Advanced Response to

Request for Additional Information No. 495(5841), Revision 0

U. S. EPR Standard Design Certification

Question 19-351:**OPEN ITEM****Follow-up to RAI 234, Question 19-307**

Figure 351-1- Fragility curves for the sub-areas of the U.S.EPR™ containment and the composite fragility curve at 309°F

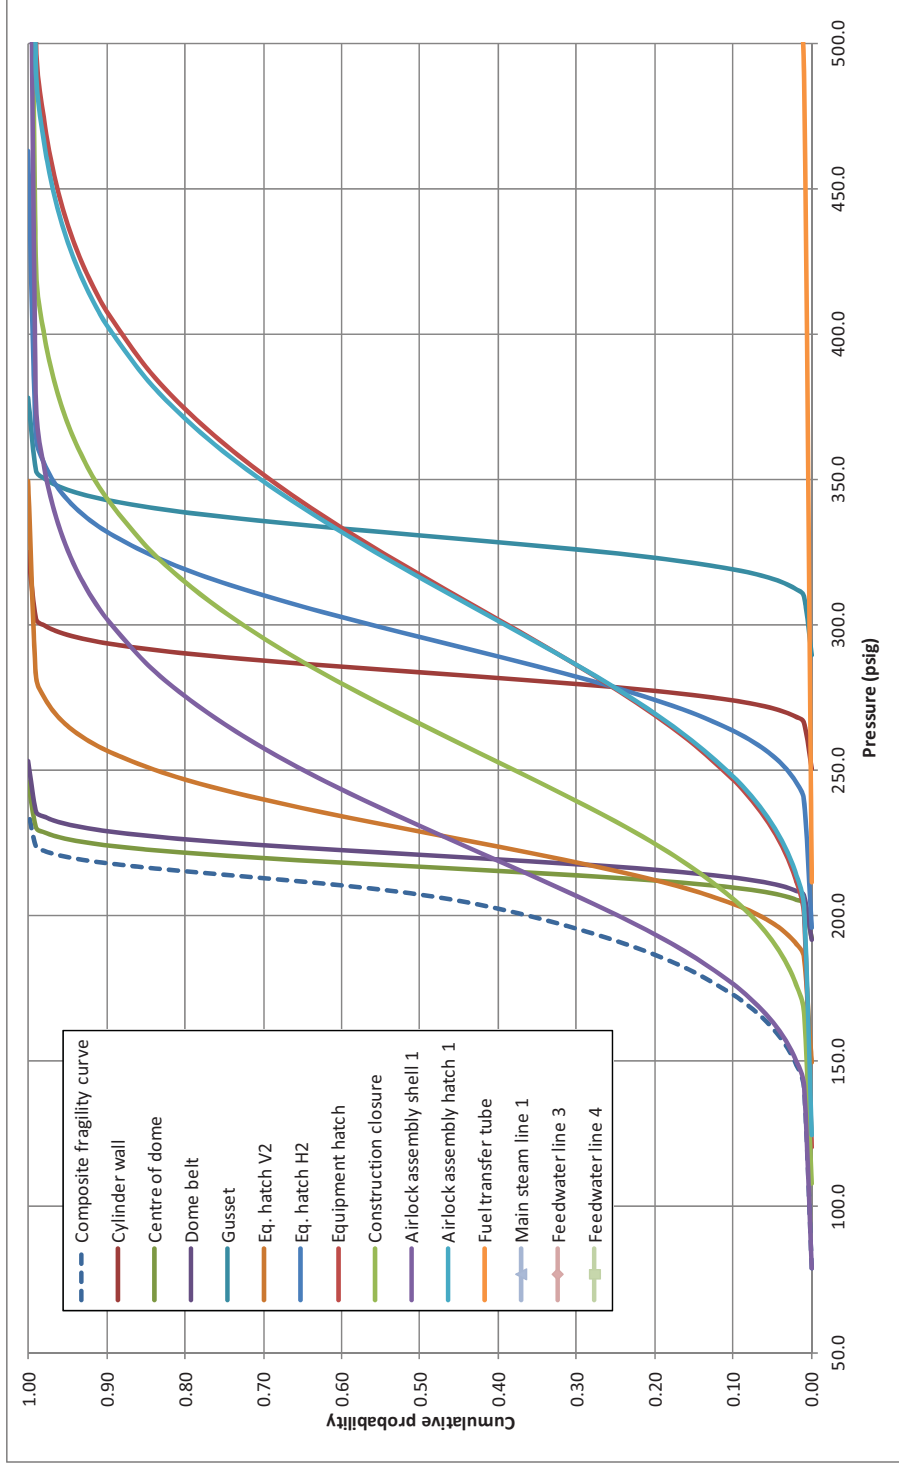
Therefore, the staff requests that the applicant revise the containment fragility analysis to include the latest design details and provide revised containment pressure fragility.

As a result of the partially overlapping fragility curves, the curves for the different structural sections have been combined to calculate the containment composite fragility curve (CCFC). The CCFC, generated through the use of a Monte Carlo sampling, combines the results from each of the individual failure areas into a single distribution representing the containment fragility. For every pressure sampled, the lowest failure probability of all containment locations is assigned.

The resulting pressure probability distribution is shown on Figure 351-1. A Monte Carlo simulation with 1,000,000 trials, and no correlation between the different structural sections, provided the following results for the composite fragility curve:

- Mean: 201 psig (about 3 times the design pressure).
- Media: 207 psig.
- Minimum (of all the values generated during the run): 87 psig.
- Maximum (of all the values generated during the run): 234 psig.
- Standard Deviation: 19 psig.
